Northwest District Association

RE: Appeal of LU 18-187493 HRM AD Buck-Prager Site

This letter contains the basis of our appeal. The first three pages are a summary of how the approval criteria are not met and the procedural errors in this case. The following pages are a more detailed analysis, including photographs of the surrounding area.

Attachment A – Map Showing Adjacent Historic Properties

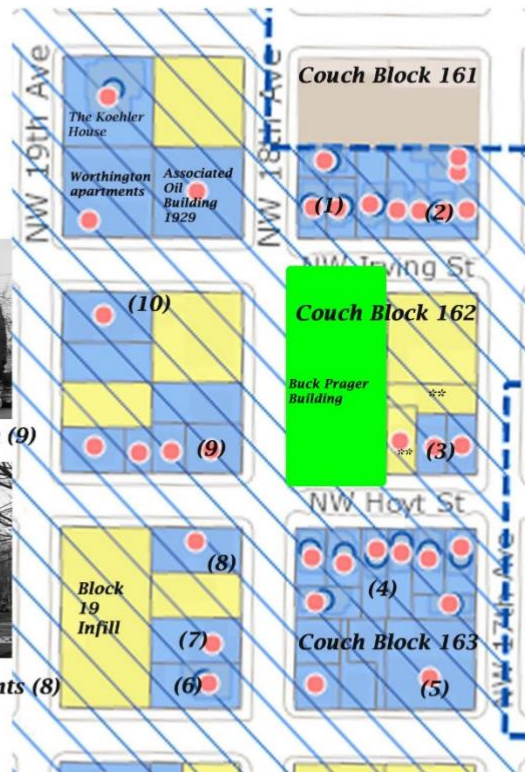
This area of Couch, Trenkmann, and Campbell properties is particularly significant because the houses are similarly small-scaled and from the same period, because so many remain, and because they form a large cluster. At the end of the 19th century, they encouraged similar development in the area. More recently, their rehabilitation in the early 1970s encouraged historic preservation and revitalization throughout the Northwest District. Attachment A is a map with historic photos of surrounding properties. Attachment B is current photos. (The map and photos were submitted to the Landmarks Commission and are part of the record.)

These well-documented adjacent properties, many of which are individually listed on the National Register of Historic Places, are barely mentioned in the decision. Without consideration of the design, context, and historic significance of these immediately surrounding properties, a finding that the North Building is “compatible with the historic qualities of the district as identified in the Historic Context Statement” cannot be made.

Above: Across 18th Ave looking west on Hoyt St (church converted to residential units across from site; William Walker Apts at left)

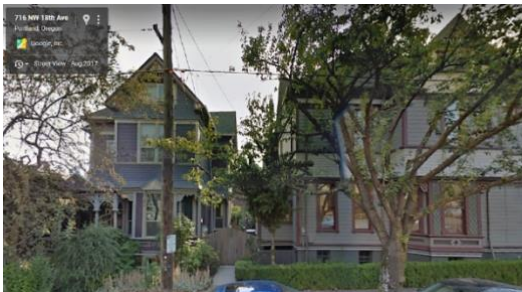
The findings for the South Addition also mention providing a landscaped buffer along Hoyt Street; however, the proposed buffer is only 13 inches deep, much less than the landscaped setbacks of 10 feet or more in front of the nine existing houses on Hoyt Street. The findings also refer incorrectly to NW 18th Avenue as commercial (it is primarily residential at this location), and to providing mid-block entrances, which are not typical of the area.

As already mentioned, the South Addition setback from Hoyt is a mere 13 inches. The North Building setback from Irving is just 3-1/2 feet. These are totally inconsistent with the 10-foot or greater setbacks of the existing, historic residential structures on these street frontages. There is no setback from NW 18th, although most buildings near the site have some setback from 18th; this is also incompatible.
